ALERT SERVICE BULLETIN
REVISION NOTICE

**SUBJECT: REVISION "A" TO ALERT SERVICE BULLETIN 210-09-06:
TAIL ROTOR BLADE P/N 210-010-100-101, INSPECTION OF.**

NO. 210-09-06

SUBJECT: TAIL ROTOR BLADE P/N 210-010-100-101 INSPECTION OF.

Figure 1

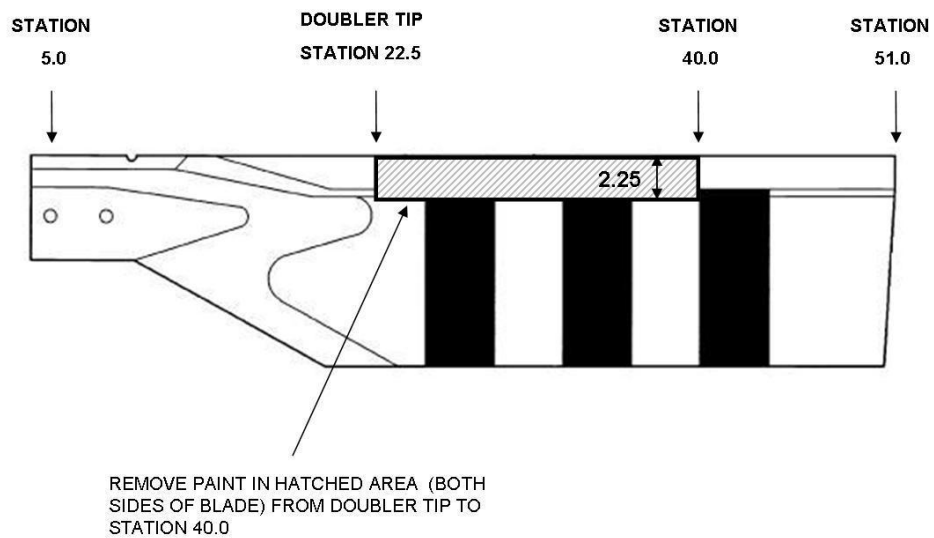
4. Ensure that all paint (on the spar only) is removed from the first 2.25 inches of the leading edge (chordwise) and from the B.S 22.5 (doubler tip) to B.S. 40.0. Refer to Figure 1. This will expose the spar up to the fillet between the blade spar and skin. A fillet filled with adhesive runs spanwise between the blade spar and the skin 2.25 inches aft of the blade leading edge, both inboard and outboard sides. The primary area to be inspected runs along the edge of the spar fillet and a half inch forward of this point. (Between 1.75 and 2.25 inch from the leading edge of the blade and from Blade Stations 22.5 to 40.0, both inboard and outboard sides).

5. Wipe area with a clean cloth dampened with alcohol (C-385) or aliphatic naphtha (C-305) and dry thoroughly.
6. Carry out a detailed visual inspection of the spar for corrosion and/or pitting using a 3-power or higher magnifying glass. Anomalies on the steel spar 0.003 inch deep or less must be polished out in accordance with BHT-PUB 92-004-23 MM.

Any defect greater than 0.003 inch deep is cause for rejection and the blade must be removed from service.
